PRODUCT CHANGE NOTIFICATION

Product Identification: Bel 2xN ICMs, xxxx-xxxx-xxx

PCN Number: PC2170087

WAS

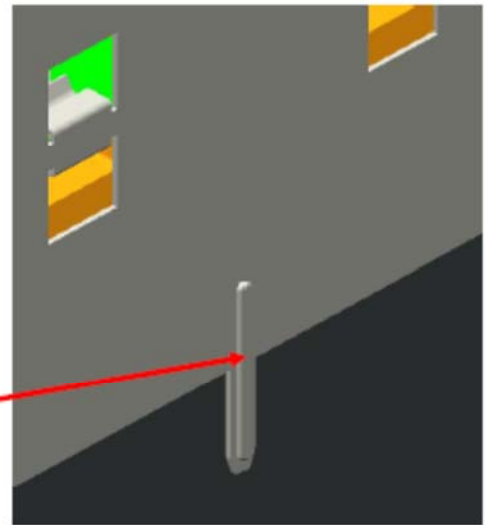
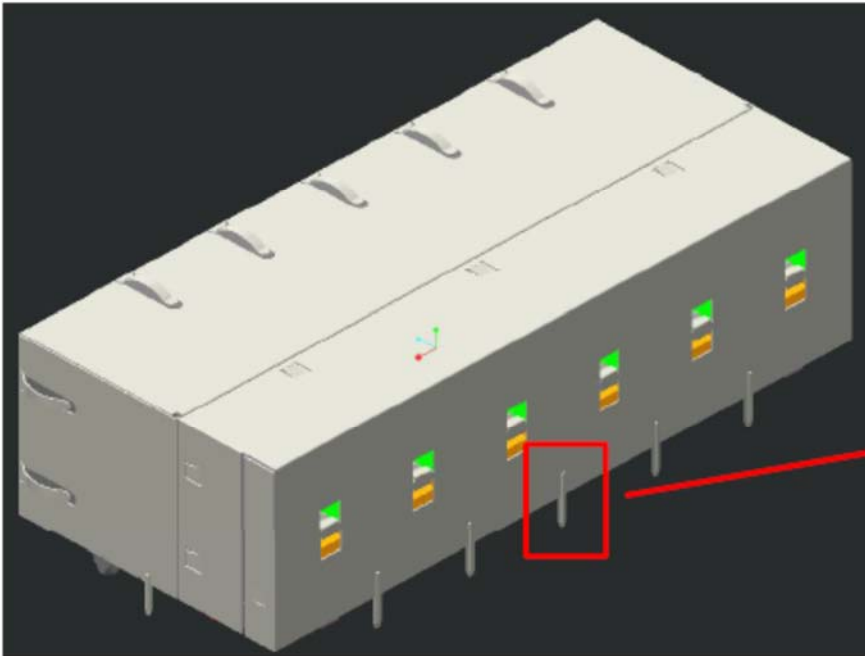
Description of the Change (s): Bel is updating the rear shield grounding lead design, adding a rib to the lead. This rib will enhance the strength of the rear shield grounding leads and help prevent deformation during handling of the ICMs prior to assembly onto a printed circuit board, please refer to the image below for more details. Final dimensions and our OQC (Outgoing Quality Control) inspection standard will remain the same.

Add rib on the ground lead
